Site Technical Query - Form

TQ Number:		Project:	
CW2144960	-A010- 0069	Oyu Tolgoi Underground Project	
A. To be completed by or on behalf of the Contractor			
Contractor/Sub-Contractor Name:	MCS International	Date Response	27/02/2022
Contract Title:	Booster Fan installations	Plant Area &	1833
Contract No.	CW2144960	Contractor TQ Number:	BF-0415-TQ-0069
Discipline Codes (Mandatory) D1 (CSA) - <input type="checkbox"/> D2 (MP) - <input checked="" type="checkbox"/> D3 (E&I) - <input type="checkbox"/> D4 (Other) - <input type="checkbox"/>			
<i>Description of Technical Query (List affected drawings and specifications):</i> 1833B Fan area : Monorail hoist clashed with target plate rock bolt The monorail hoist installed on the monorail beam is clashing with monorail target plate rock bolt. Refer to the attached field photos.			
<input type="checkbox"/> Routine <input checked="" type="checkbox"/> Urgent Refer Technical Query instructions

0 YU TOLGOI UNDERGROUND PROJECT
5 TONNE
LIFTING EQUIPMENT
ULTRA LOW HEIGHT HOIST

If Cost or Schedule Impact are associated with this TQ, it must be discussed separately with Jacobs Contract team.

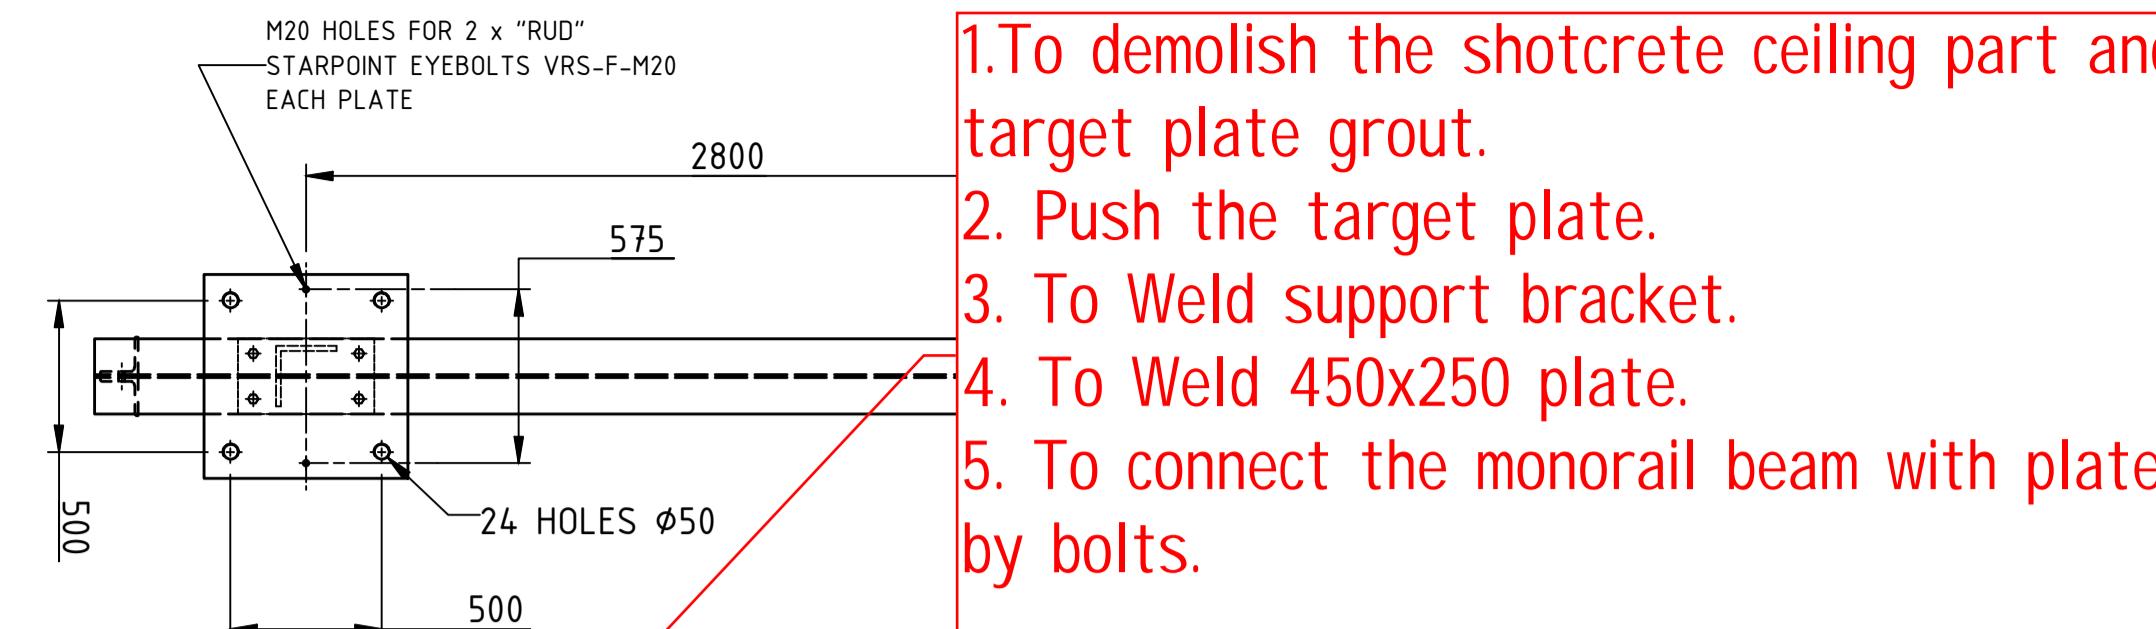
<i>Proposed Action (List all attachments)</i> The contractor is proposed the following option. 1. To demolish the shotcrete top of target plate and target plate grout. Also, to push the target plate. (in page 4)			
Effect on cost (USD):	YES		
Effect on schedule (Days):	YES		
Effect on quality:	NO		
Requested by (Name):	Delgersuren.N	Position:	SMP Engineer
Signature:		Date: (dd/mm/yyyy)	24/02/2022

1. To demolish the shotcrete ceiling part and target plate grout.
2. Push the target plate.
3. To Weld support bracket.
4. To Weld 450x250 plate.
5. To connect the monorail beam with plate by bolts.

Proposal is acceptable subject to following comments:

- Demolish existing grout completely and chip shotcrete surface to create a room for additional vertical L20 as required;
- Push target plate as much as possible within angle tolerance as specified in standard drawings;
- Re-grout target plate and pre-tension rock bolts. Cut projection of rock bolts maintaining minimum 3 threads beyond the nut after completion of works.
- Note that the chipping of the shotcrete is to be made subject to inspection and agreement by OT Geotechnical engineer.
